Full-scope EIA Temelin

Report to the Federal Government of Austria

Federal Environment Agency – Austria

Vienna, June 2001

Figure 1: Temelin Emergency Planning Zones Delineation

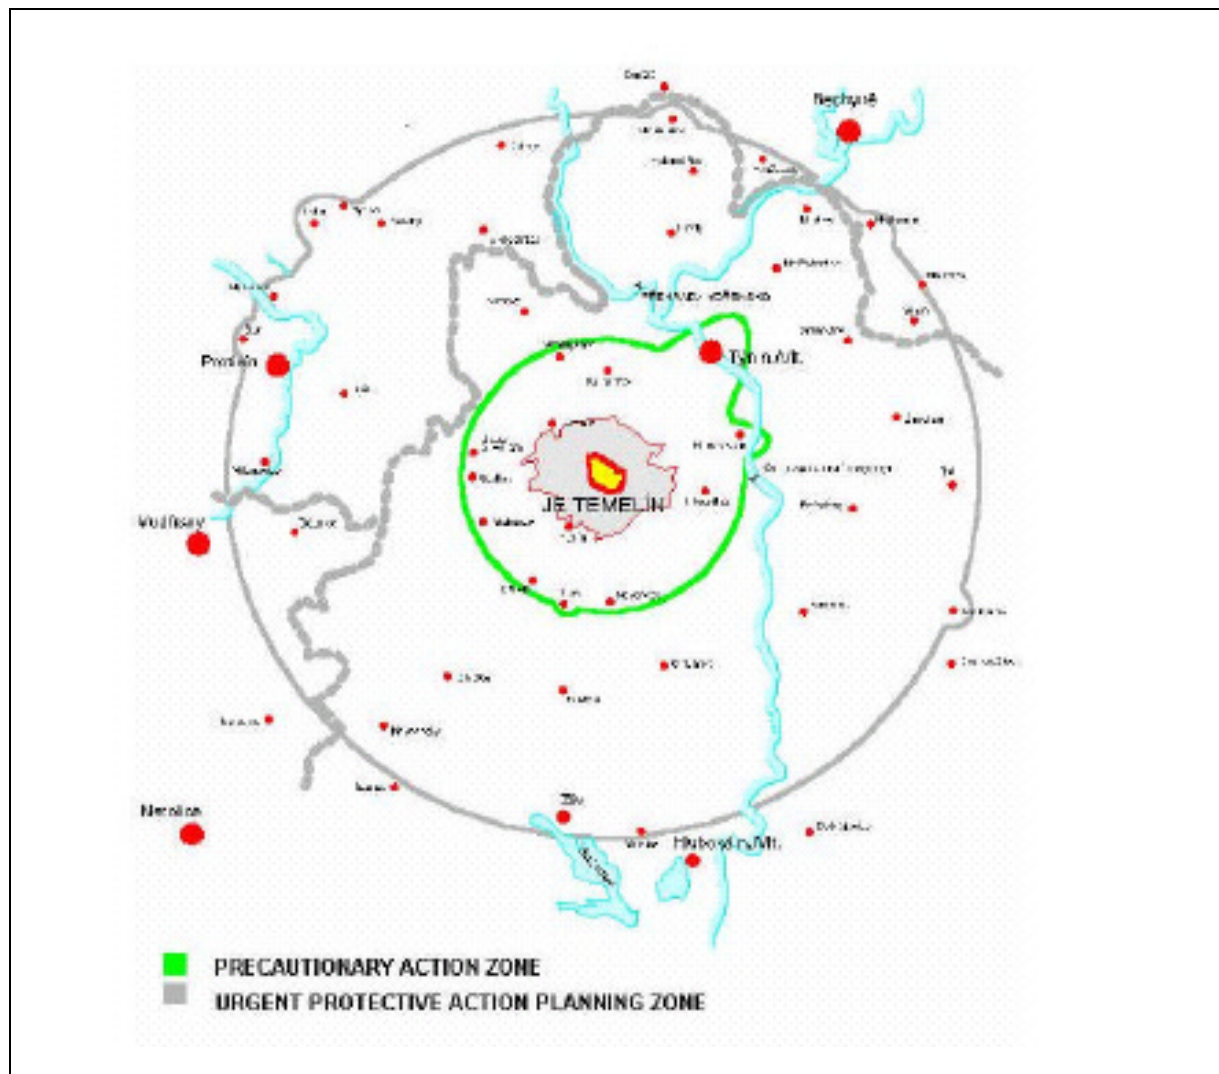
The IAEA definition for determination of the zones leaves significant room to manoeuvre concerning the concrete implementation. For this reason, it would be desirable to obtain more information about the method for determining the size of zone 1 and 2 for Temelin.

Figure 2: Cross border character of emergency planning zones
(see IAEA-TECDOC-953, page 11)

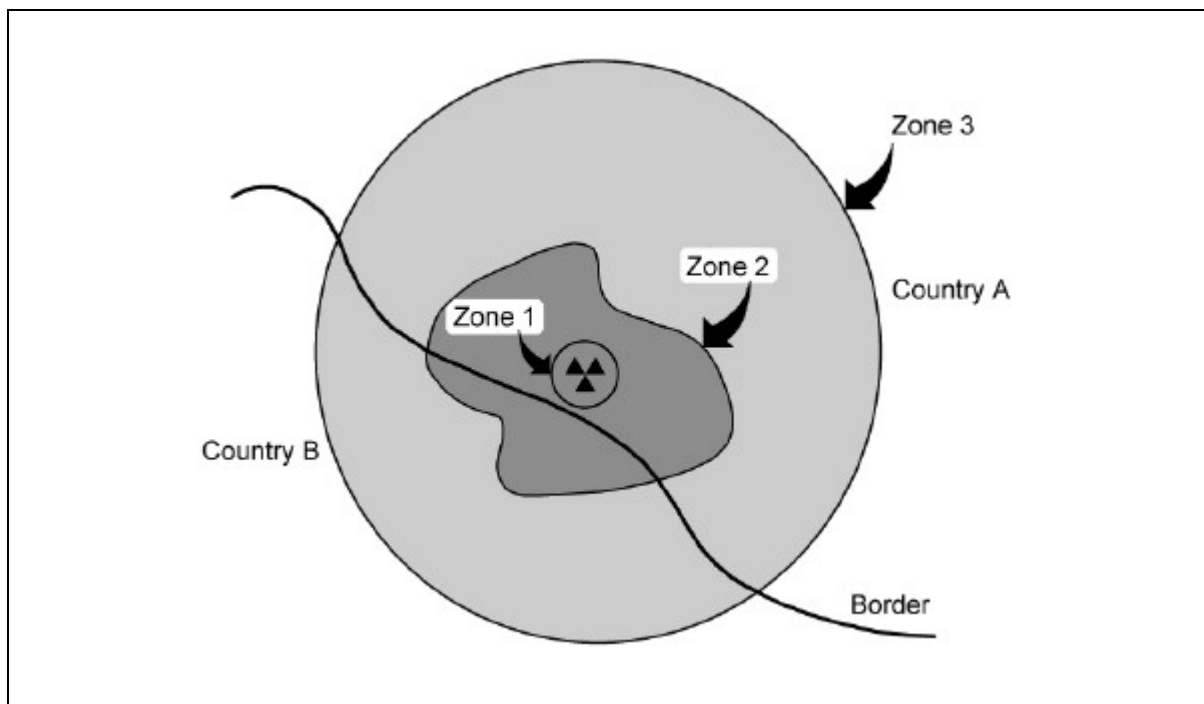
Die IAEA recommends to determine the emergency planning zones as a cross border zone: "*It is important to note that the zones do not stop at national borders.*" (IAEA TECDOC-953, page 11). This is apparent also in Figure 2 (IAEA-TECDOC-953, page 11) describing the concept of emergency planning zones.

The guideline given for the radius of zone 3 (LPZ) is a distance of 50-100 km from the NPP. According to this recommendation also Austrian territory would be part of zone 3, because the shortest distance between the NPP Temelin and the Austrian border is ~50 km. The fact, that the LPZ should include also Austrian and German territory was confirmed by Czech experts during the discussion at the above mentioned workshop in Prague.
